Product Change Notification

107638 - 00

Change Notification #: 107638 - 00
Change Title: Intel® IP Network Server NSW1U, PCN 107638-00, Product Design, Design change to Fan Assemblies, adds Isolation for Battery, and change DC Power Supply.
Date of Publication: June 14, 2007

Figure 2 - Post change cooling subsystem assemblies with Isolated Fan Brackets

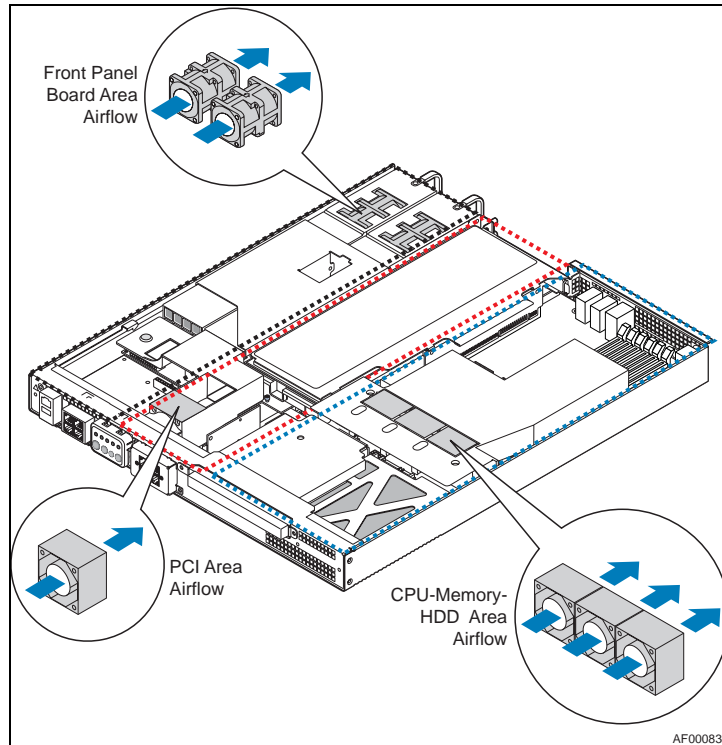
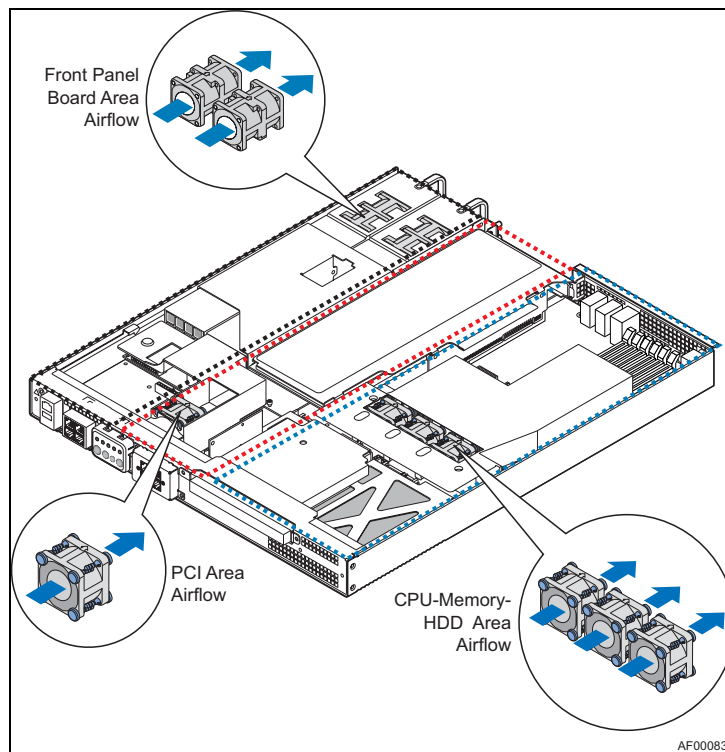
1. Fan Assemblies.

Fans assemblies change to add Isolated Fan Brackets (IFB). IFB are designed to reduce rotational vibration interference from the system fans to the hard disk drives (HDD). IFB changes will include changes to these four areas:

- a. CPU Fan Assembly – add isolation bumpers to four corners of each fan, lengthen fan wiring harness, change sheet metal bracket to accommodate fans with bumpers and fasten more securely to chassis, remove insulator on chassis below fan assembly.
- b. CPU Air Duct – change to accommodate larger CPU Fan Assembly
- c. PCI Fan Assembly – add isolation bumpers to eight corners of each fan.
- d. PCI Air Duct/Bracket Assembly – change to accommodate fans with bumpers.

Figure 1 shows pre-change cooling subsystem assemblies and Figure 2 shows the post-change cooling subsystems with IFB assemblies.

Figure 3. Battery in Relation to PCI Assembly Leg

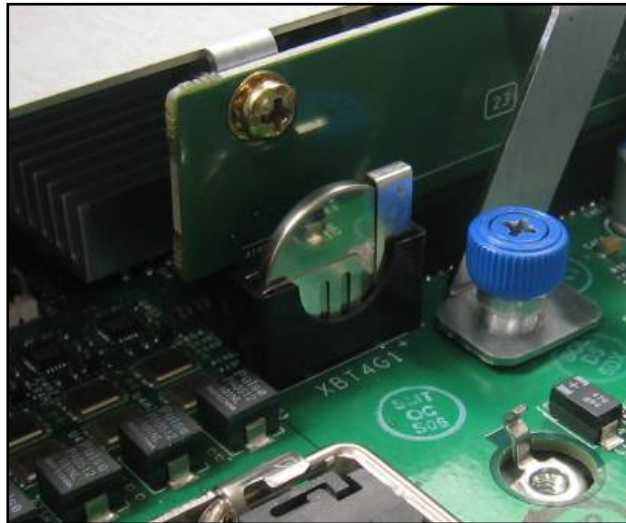
2. Battery isolation.

Battery isolation is designed to reduce the chance of the PCI assembly hitting the system battery. As seen in Figure 3, the leg of the PCI assembly is very close to the battery. In order to prevent the PCI riser card assembly from touching the battery during removal and insertion, a battery isolator is being installed around the battery. Figure 4 shows the battery isolation in place.
